3 June 2026

Section 4.55(1A) Modification Application – SSD-74670005 UNSW G25 Education Building, UNSW Kensington Campus

The proposed modifications to the approved development are detailed in **Table 1** below. Excerpts of the approved and amended architectural plans are provided at **Figure 1** to **Figure 23**.

Figure 16 Proposed plant plan

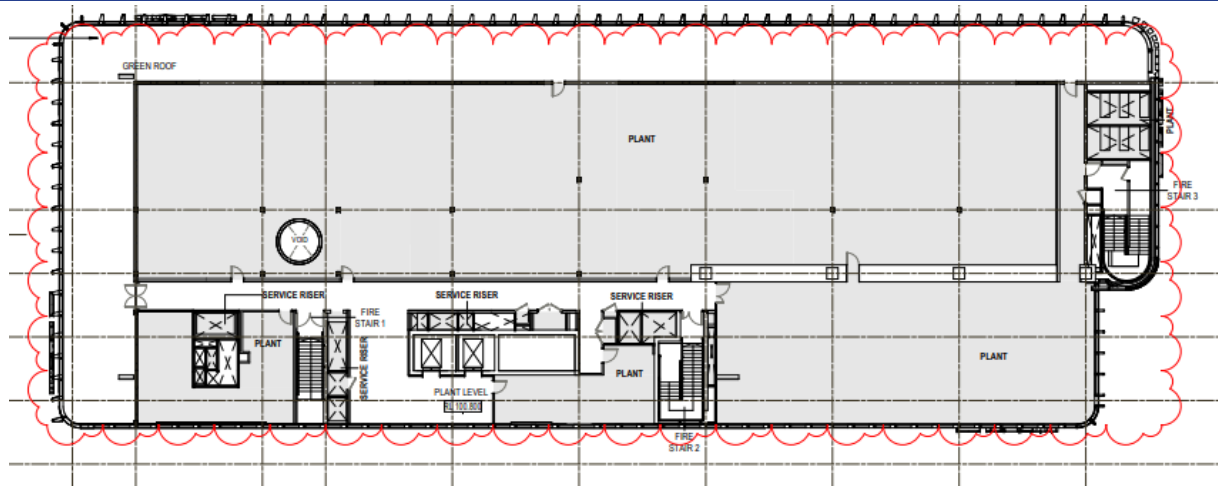
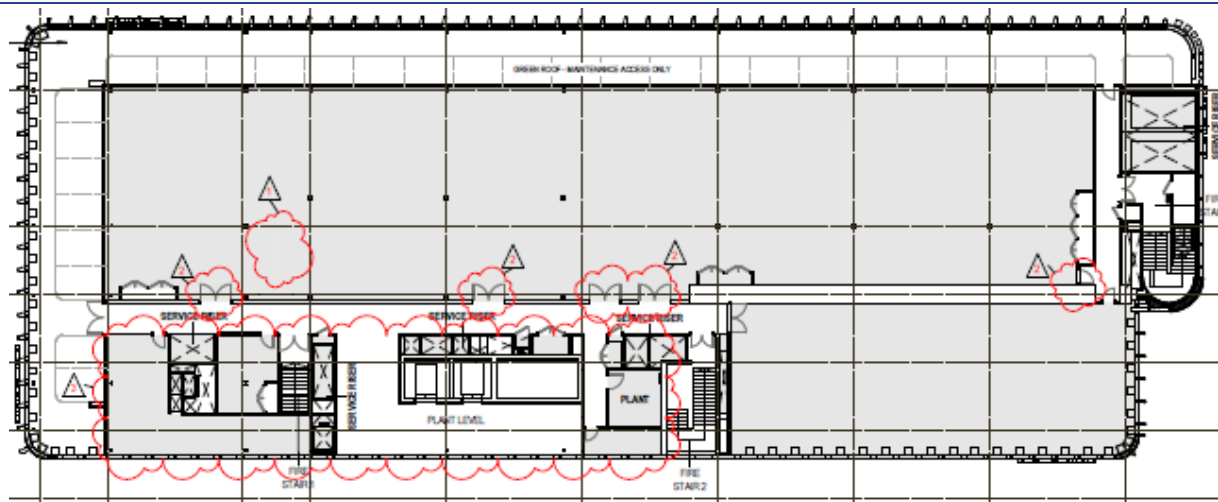
- Plant door location amendments.
- Removal of internal skylight void.
- Services partition amendments responding to further detailed coordination.
- Removal of winter gardens at relevant levels and removal of associated skylight elements.

- External rooftop garden works.
- Rooftop surface finishes.

Figure 18 Proposed roof plan

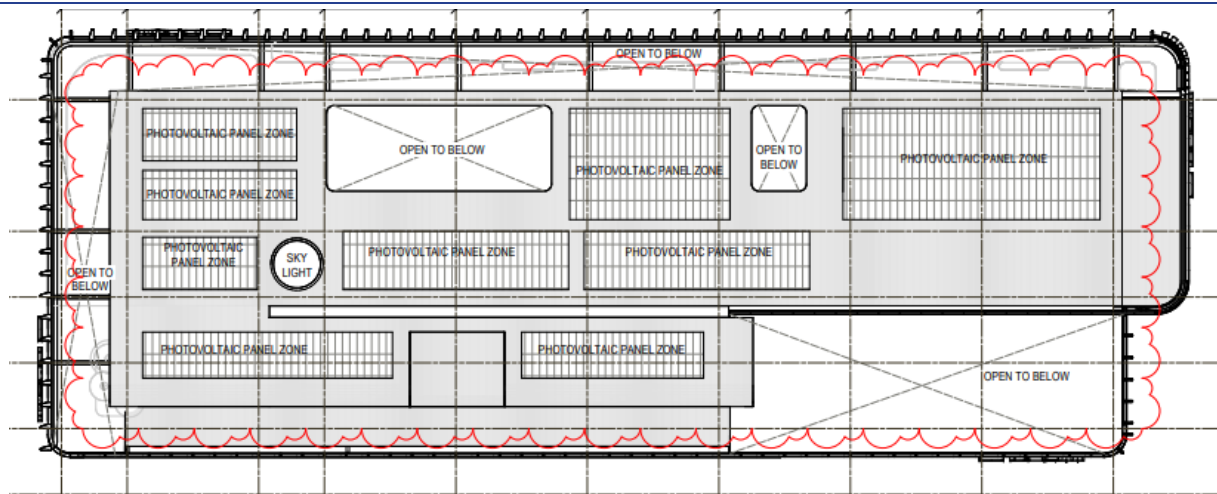
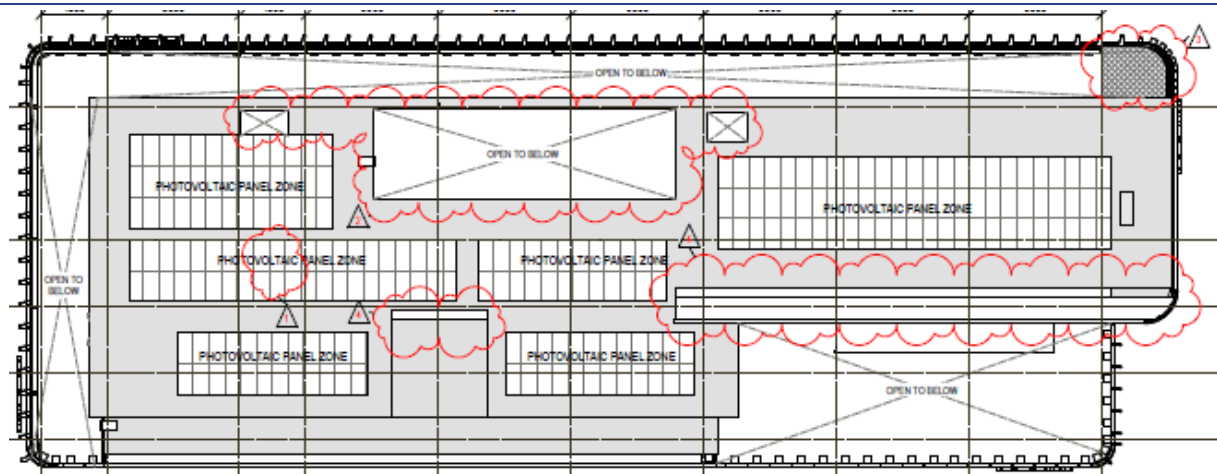
Reflects only minor design development at the roof level, comprising shifting of location of services and some functional elements with no changes to the roof form itself, as illustrated within the figures below. The amendments include:

- Removal of skylights.
- Alignment with mechanical layouts.
- Addition of roof access points.
- Alignment with the hydraulic drainage strategy.

Figure 20 Proposed north elevation

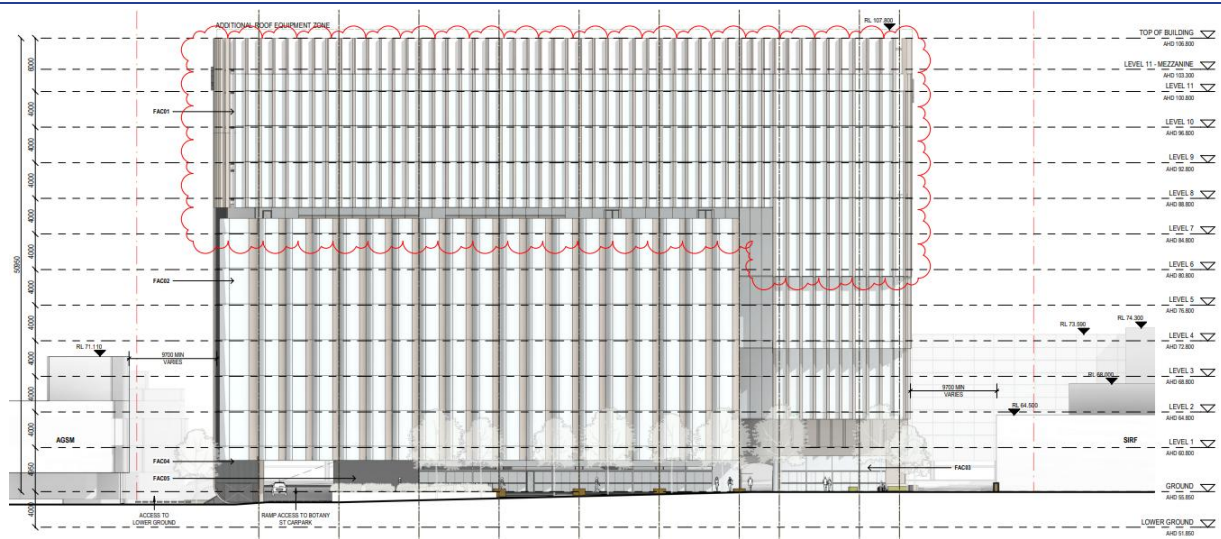
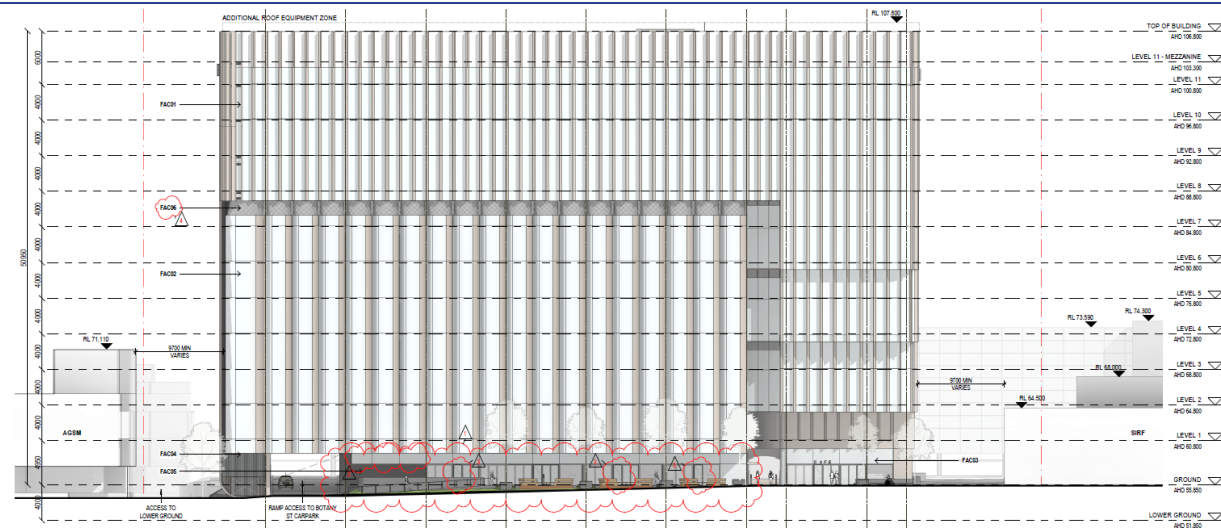
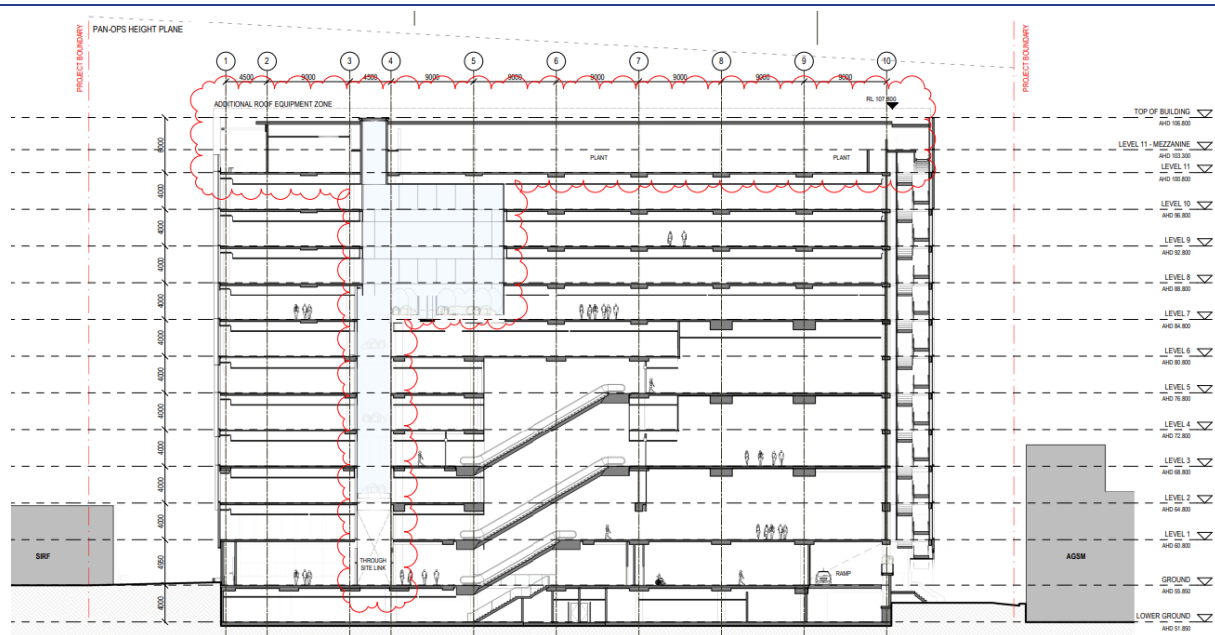
- High-level window added to the ground floor classroom under awning.
- Amended door locations in response to the amended landscape design.
- Additional safety tensile mesh FAC06 to Level 7 external terrace.
- Section changes reflecting removal of the winter gardens.

It should be noted that the additional plant area located on the southern elevation on Levels 2-7 will be treated internally with back pans behind the glazed elements, maintaining the external expression and continuity of glazing to vertical shading.

Figure 23 Proposed landscape plan

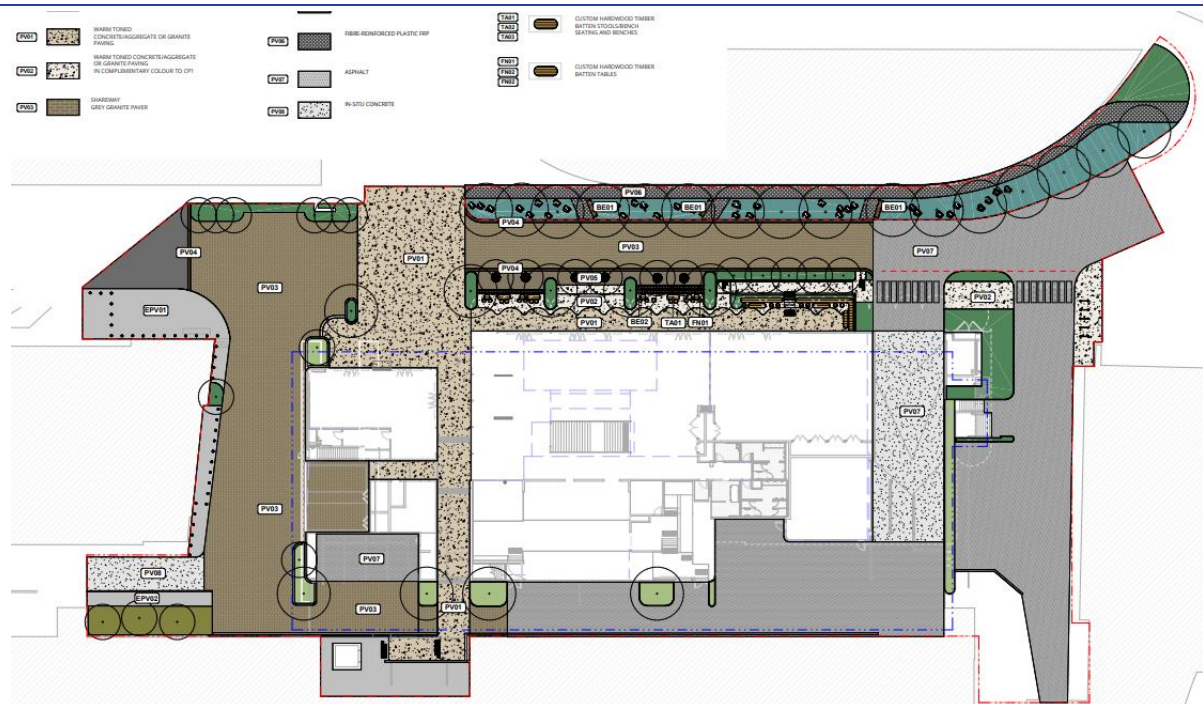
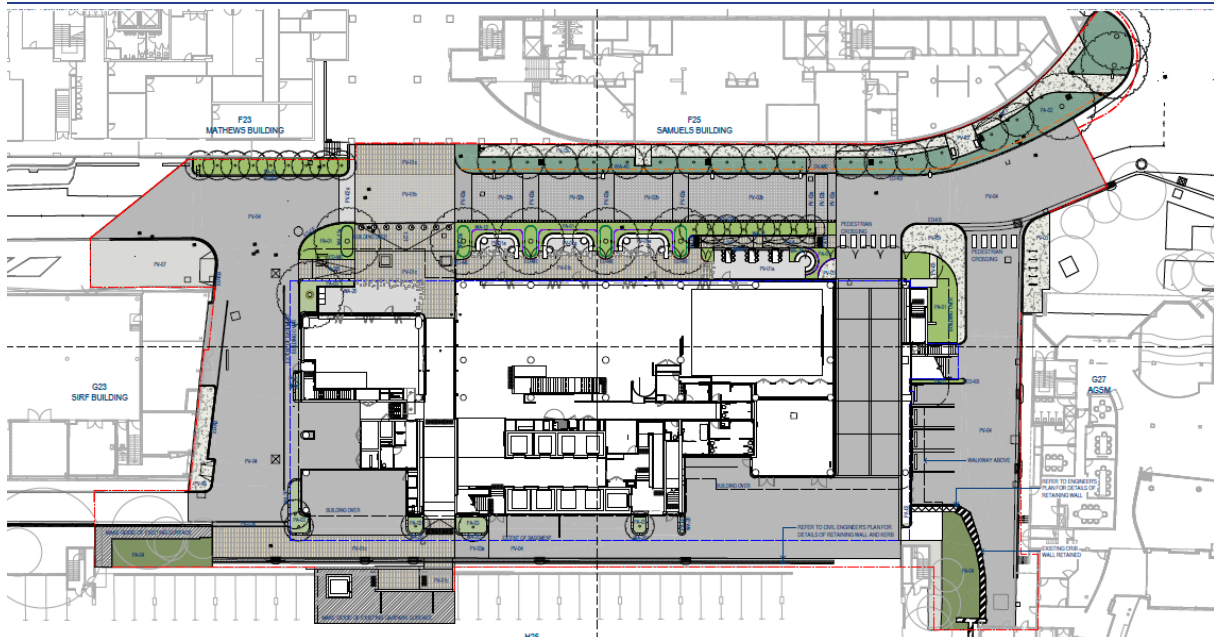
Updated landscape design including revised ground plane, planting and paving arrangements, revised swale design, new and adjusted retaining wall treatments, crossing and passing bay refinements, revised rooftop garden details, and planting updates having regard to function and microclimate. Figures demonstrating the difference between the approved and proposed landscape plans have been provided below (Figure 22 and Figure 23).

The proposed modification seeks to provide 118 trees which will comprise of the following species, Coastal Banksia (17), Quandong (21), Flindersia (9) and Straw Tree Fern (71). Overall, this is an addition of 8 trees, from the 110 new trees approved under SSD-74670005.

The landscape revisions are minor and represent design development of the approved scheme (refer to **Figure 22** and **Figure 23**). Compared with the approved landscape plan, the proposed landscape design retains the same overall landscape strategy for the site but refines a number of elements through detailed design development. In particular, the proposed scheme updates the paving and surface treatment layout, revises planter and planting bed geometry, further resolves the furniture and seating arrangement, and incorporates more detailed water-sensitive design measures including the swale and associated drainage interfaces. The planting design has also been updated through revised species selection, quantities and rooftop / terrace planting details, with the later package noting changes to improve diversity, function and microclimate response.

Figure 25 Proposed north-south elevation including addition of tensile mesh

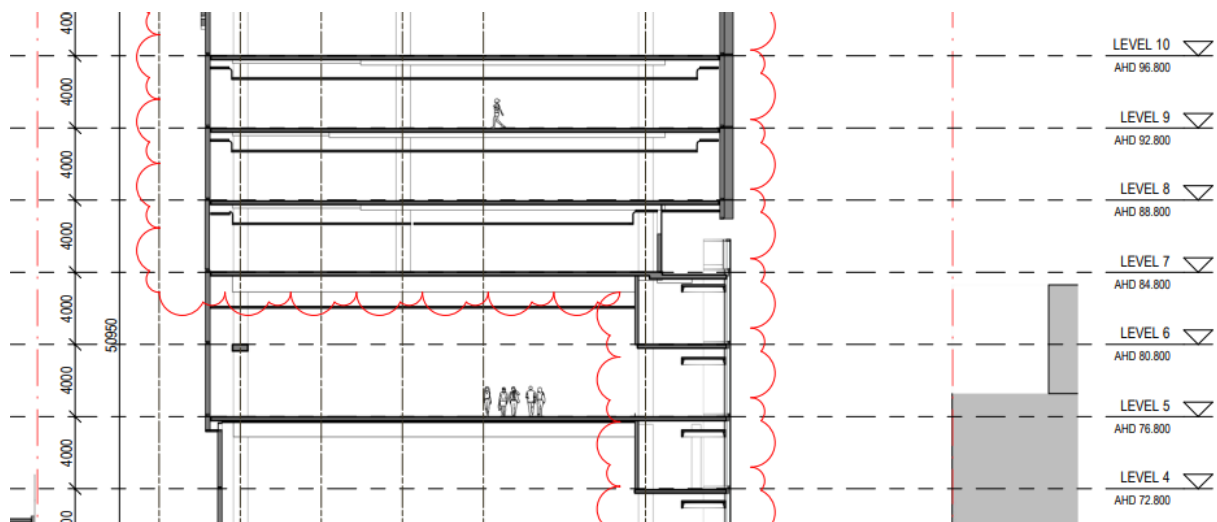
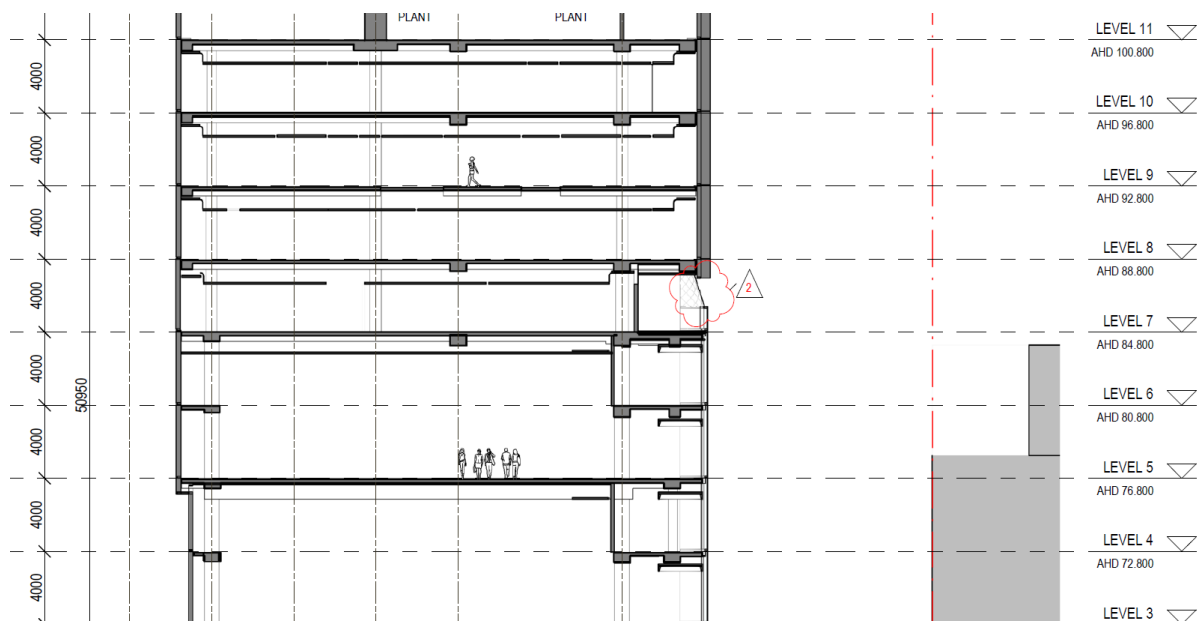
The proposed modification results in only minor refinements to the approved building façade and architectural presentation, comprising a high-level window to the ground floor classroom under the awning, amended door locations to coordinate with the updated landscape design, and the addition of safety tensile mesh to the Level 7

external terrace in response to Safety in Design considerations, which will be imperceivable from ground level (refer to **Figure 25** below).

Figure 27 Excerpt of approved vs proposed GFA plans illustrating amendments

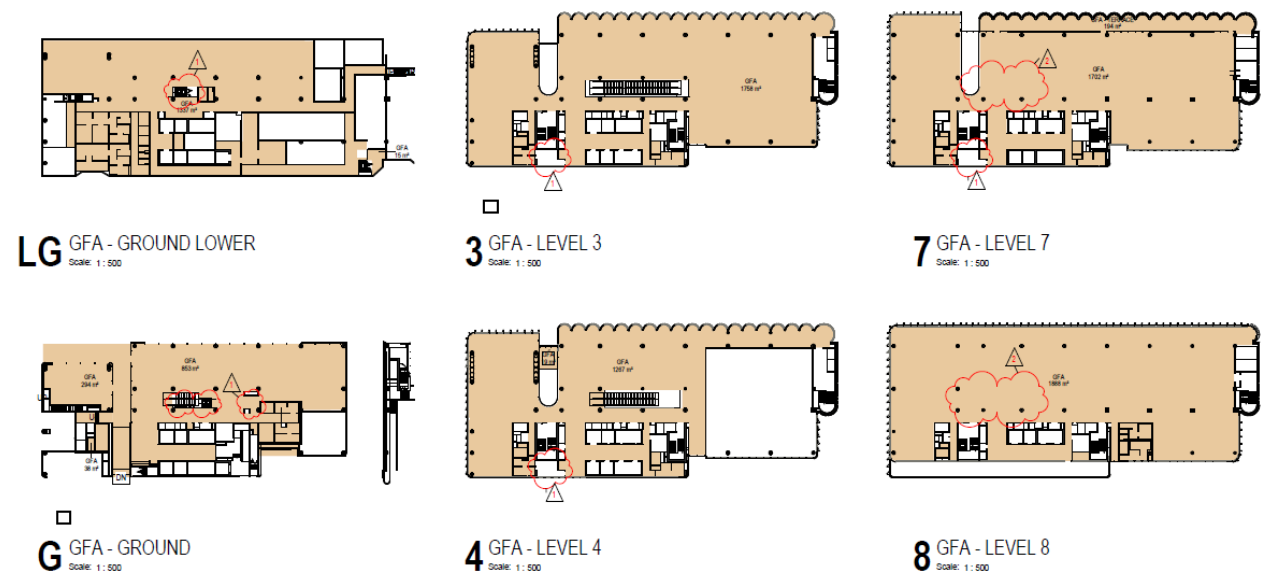
The proposed modification results in a minor increase in GFA from 19,567m² to 19,630m², being a slight increase of 63m². This change arises from detailed design development and internal rationalisation of the building, including removal of internal voids, winter gardens and skylight elements, together with refinement of stair widths, plant areas, lifts and service configurations. While there are some minor redistributions of floor area between individual levels as part of that coordination, the modification produces a minor increase in GFA across the building (refer to **Figure 27** below).
